Knockcronal Wind Farm

Gatecheck Report

Client: Statkraft
Project/Proposal No: 3206
Version: V3
Date: 2021-05-27

**Figure 6
Layout O**

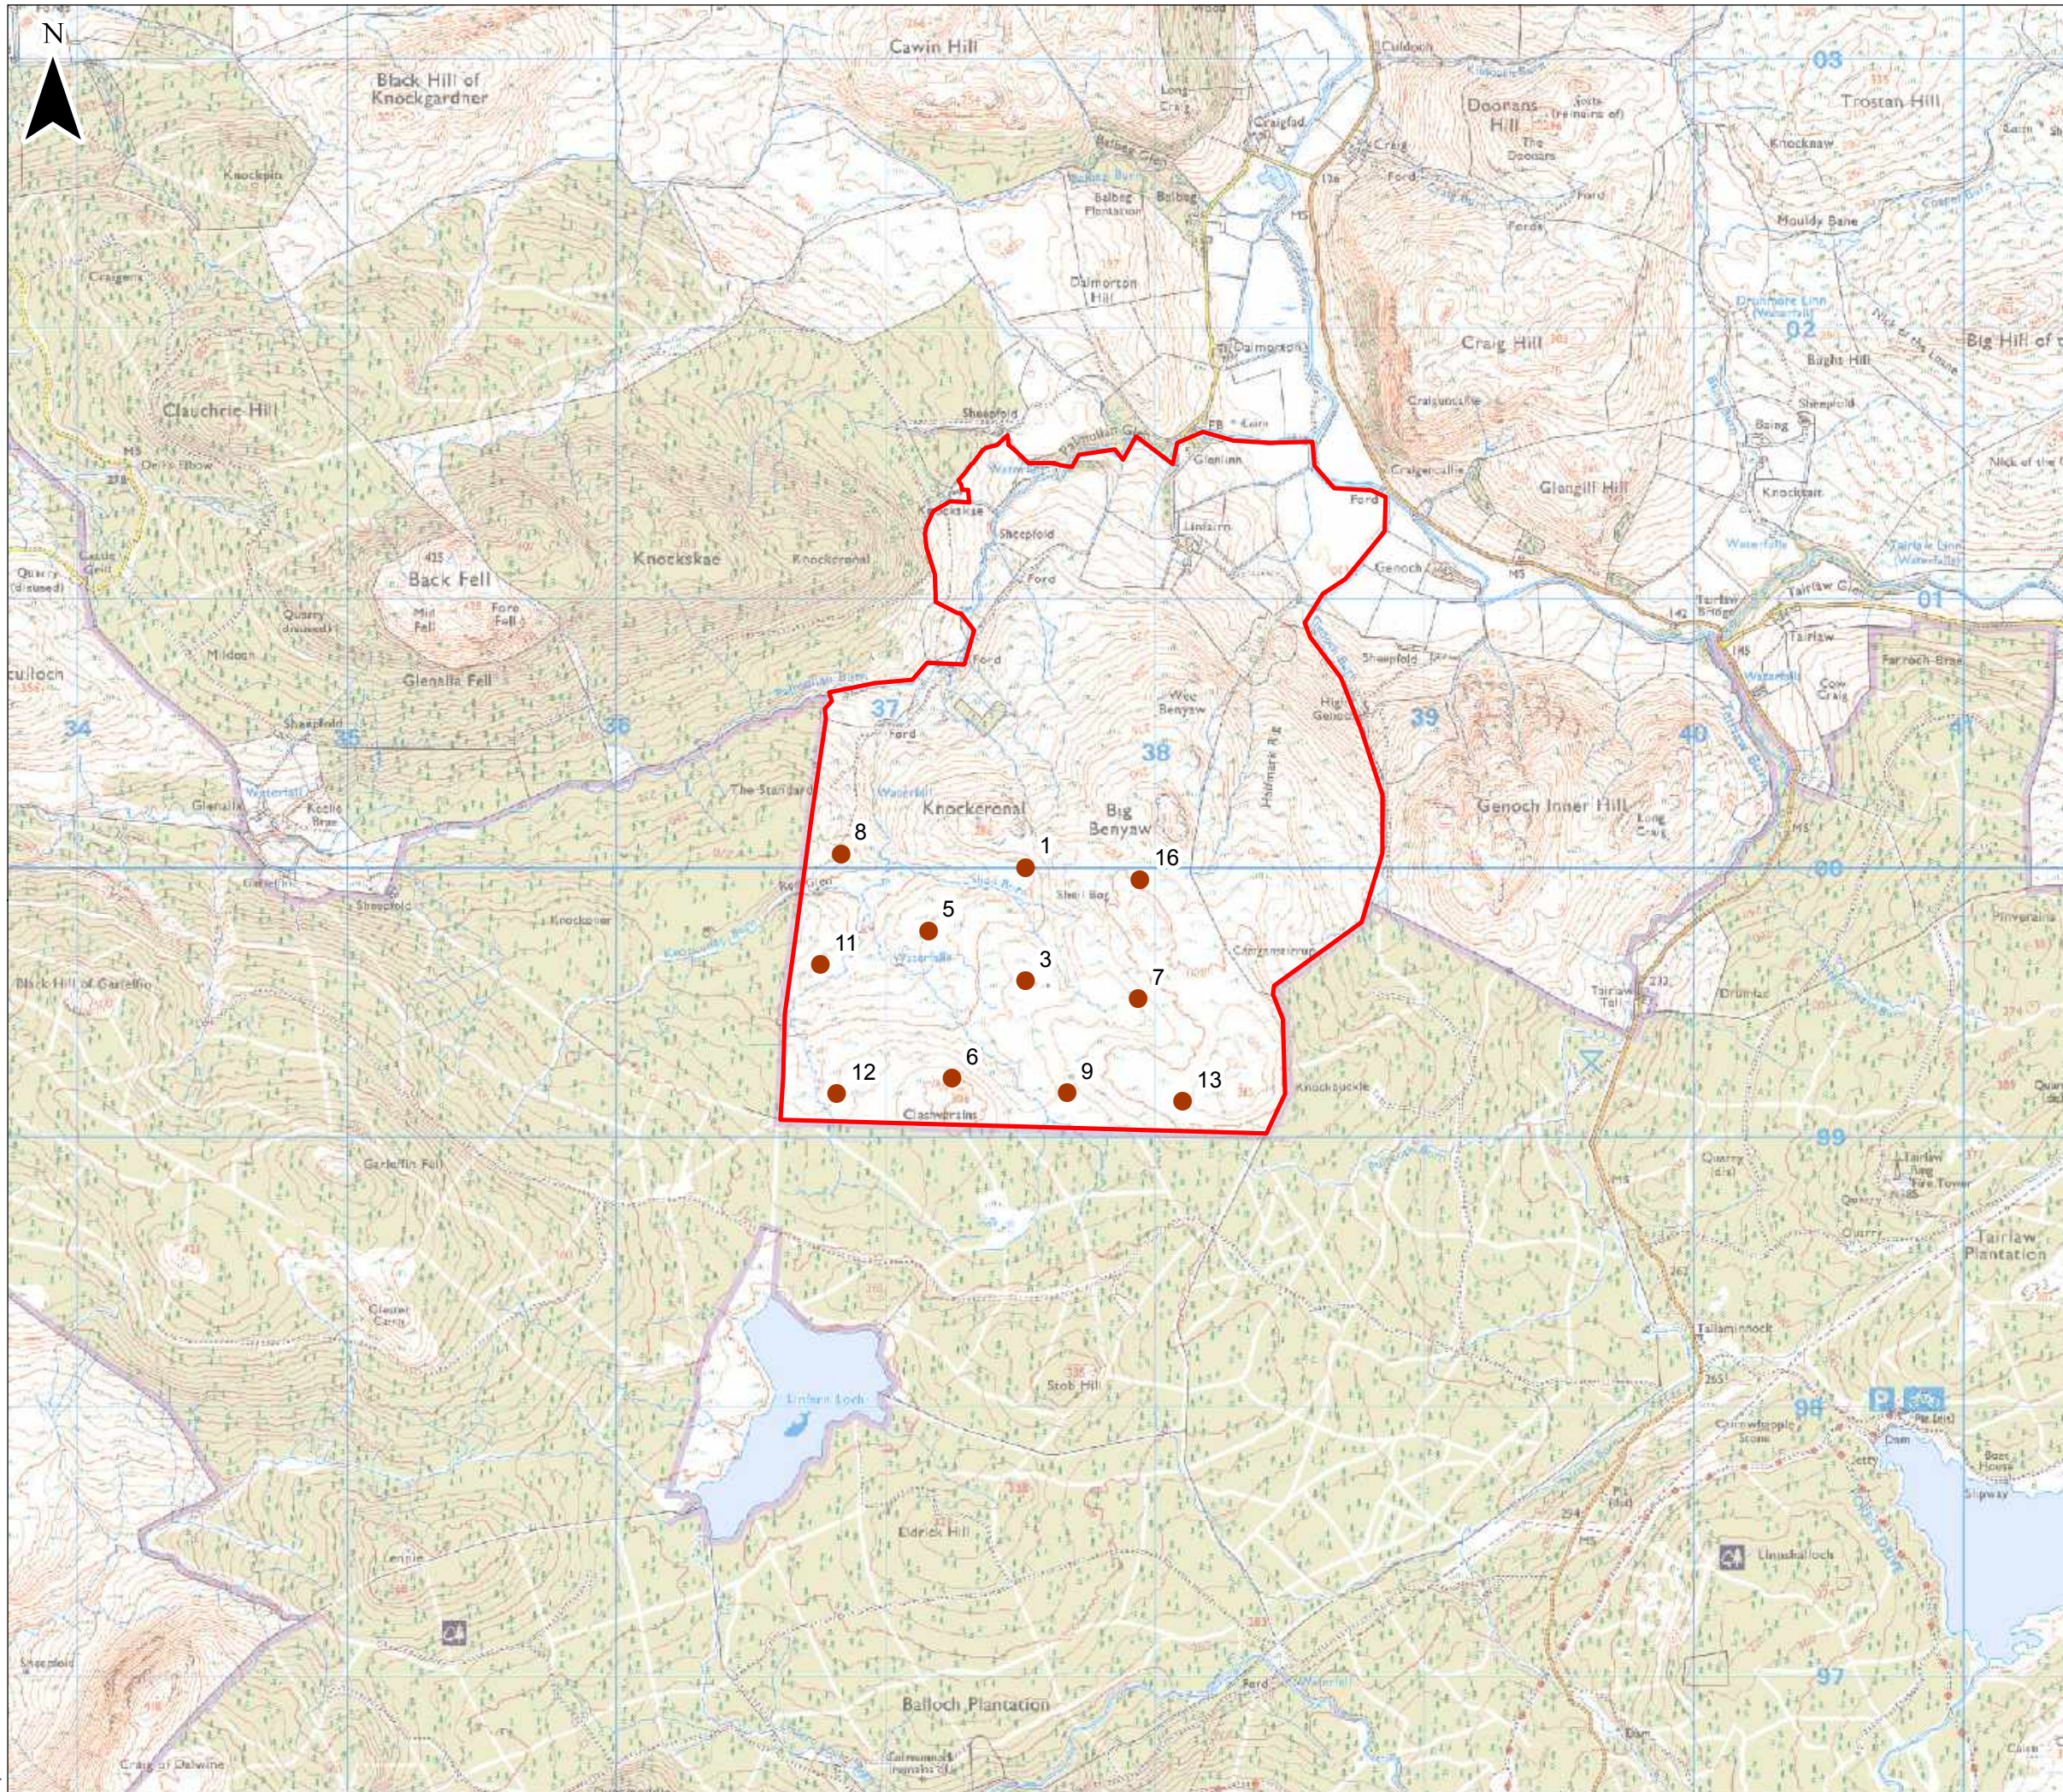
O (Figure 6)	11	September 2020	Movement of turbine T13 west and T16 south to reduce visual effects. Most other turbines were consequently moved slightly west to maintain appropriate separation distance. Continued consideration of minimising the view from Merrick WLA.
S (Figure 7)	9	March 2021	Removal of T1 and 8 and movement of turbines to increase distance from woodland buffers (minimising potential ecological impacts) and further reduce potential noise impacts. Renumbering of turbines as T1 to T9 for clarity.

**Figure 8
Layout U**

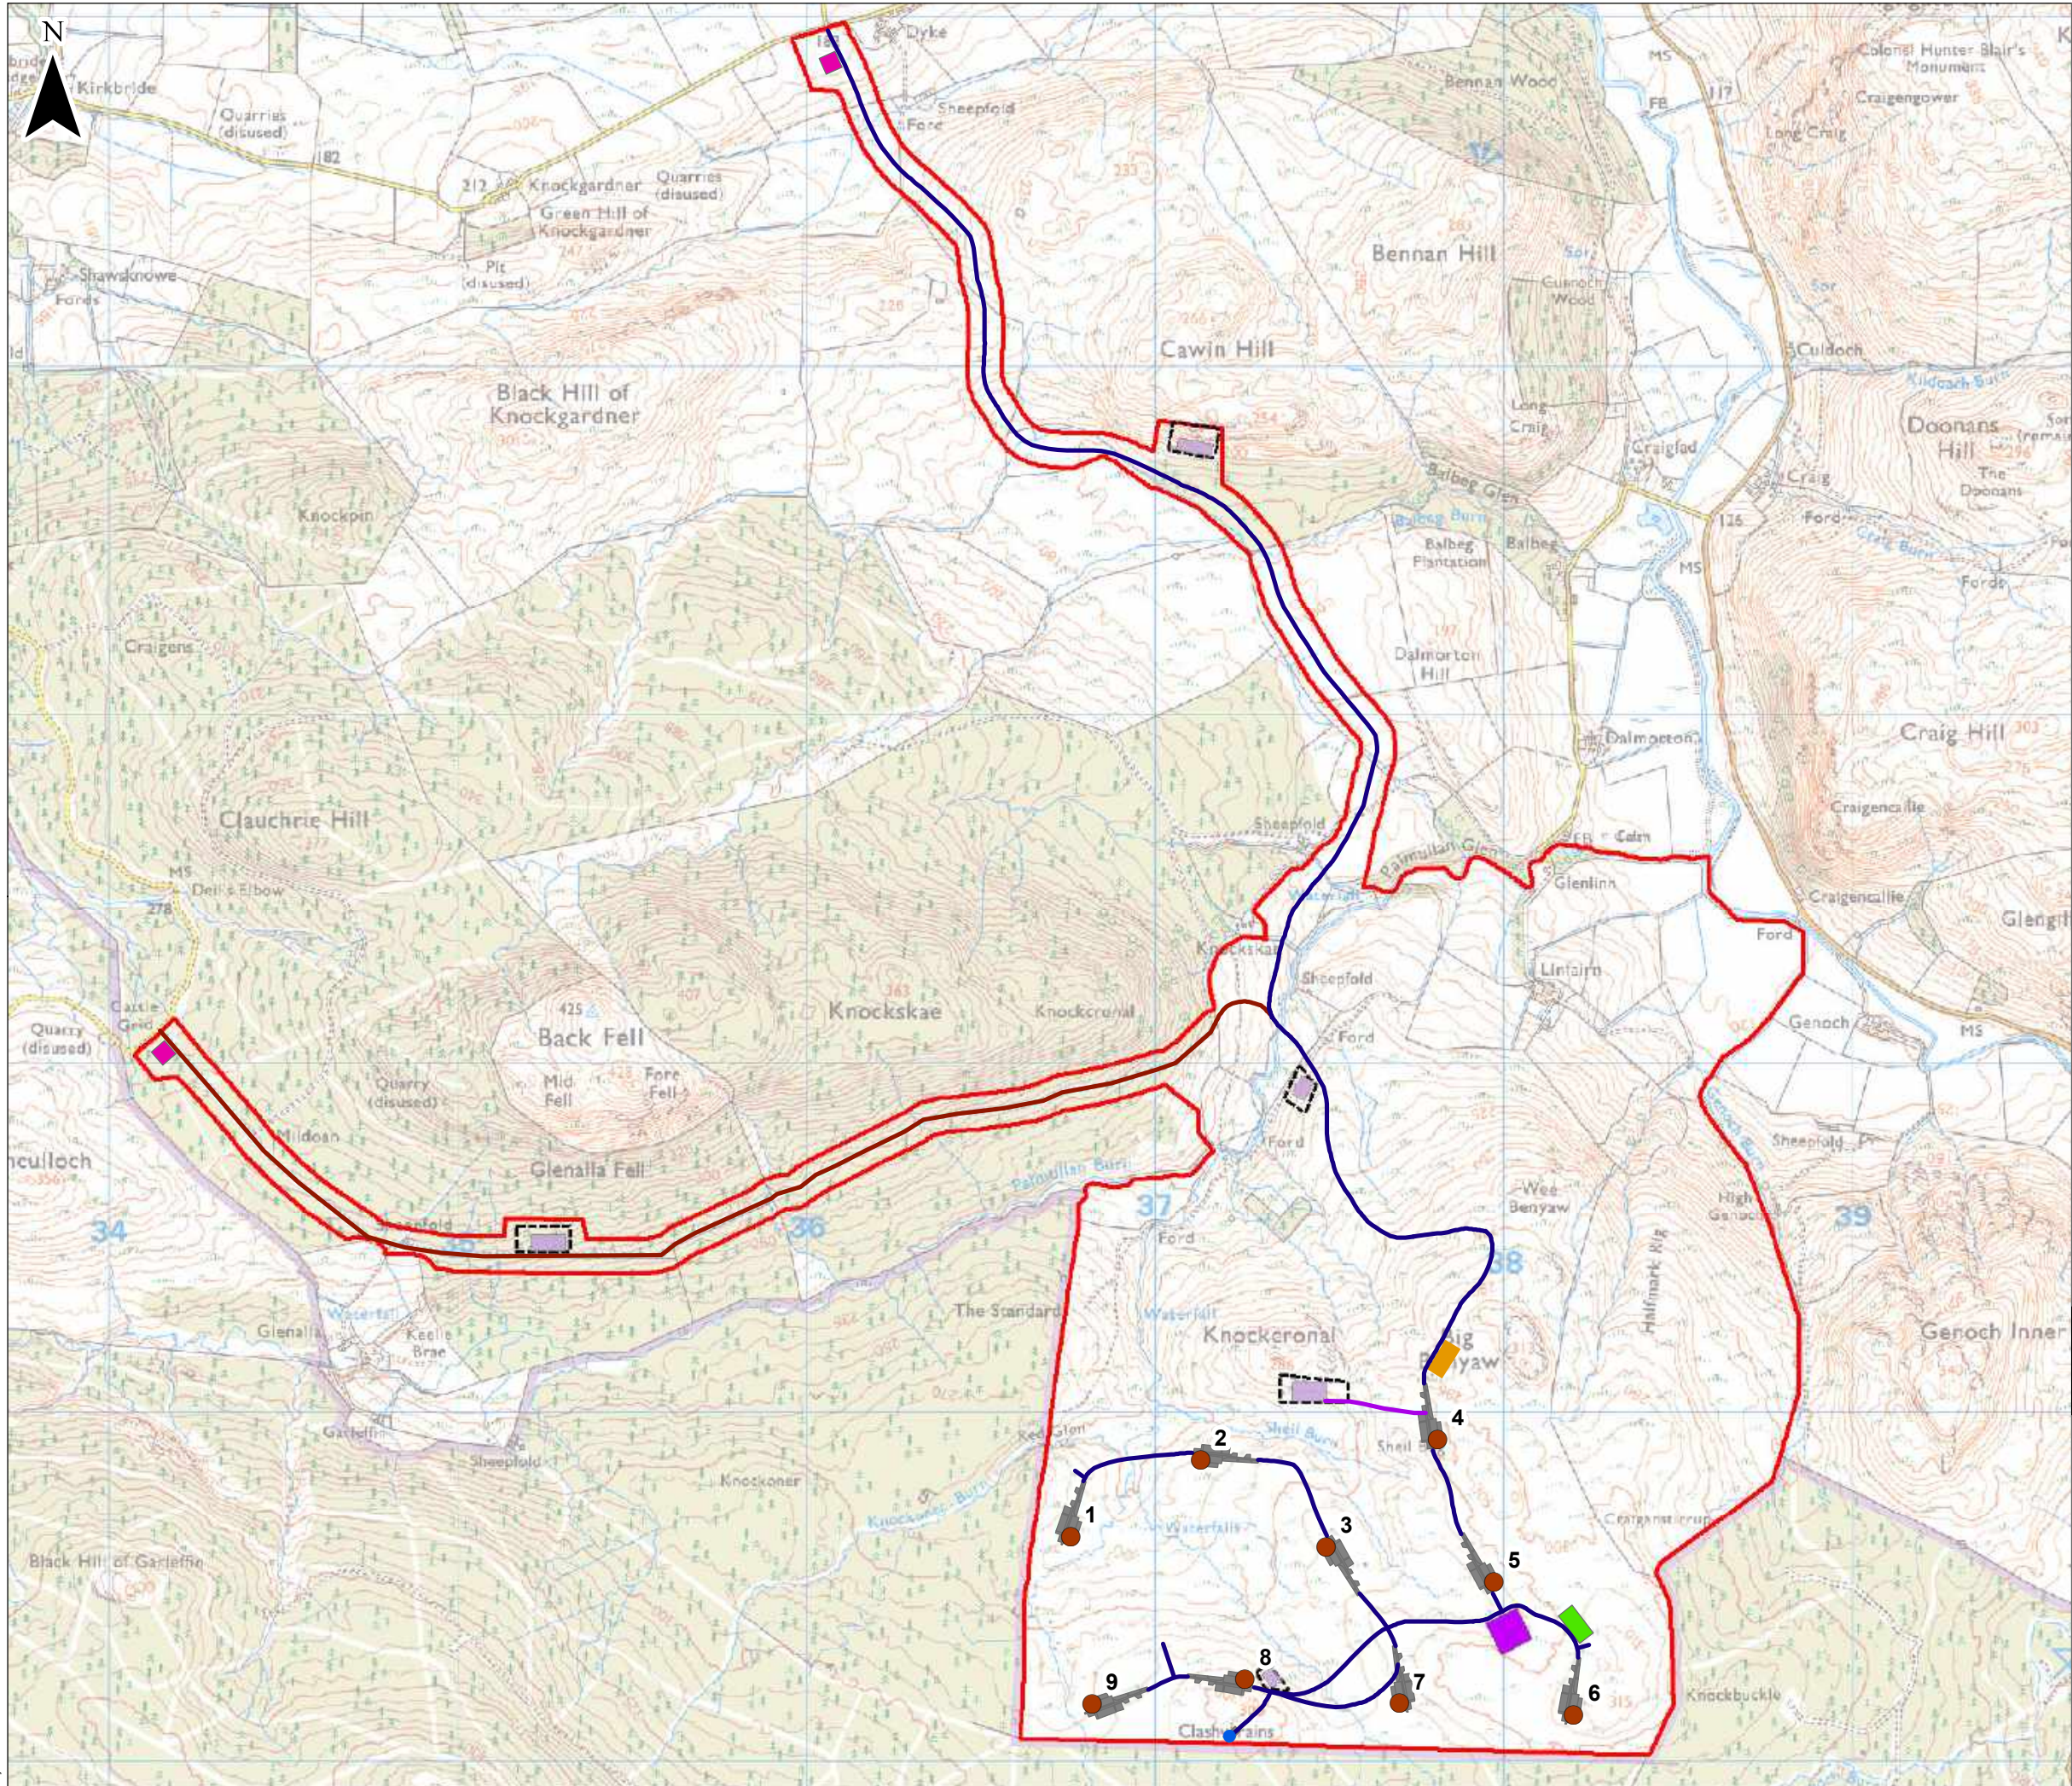
Design Iteration	No. Turbines	Date	Description
U (Figure 8)	9	April 2021	Site boundary updated to include access track. Additional access route option included from the west. Both will be included in the application, but only one will be taken forward to construction.
V (Figure 9)	9	May 2021	Design chill layout. Northern access route modified to follow the forestry access track currently under construction, which will be completed by the time of application. The forestry track will be utilised by the Proposed Development, with upgrades made as required.
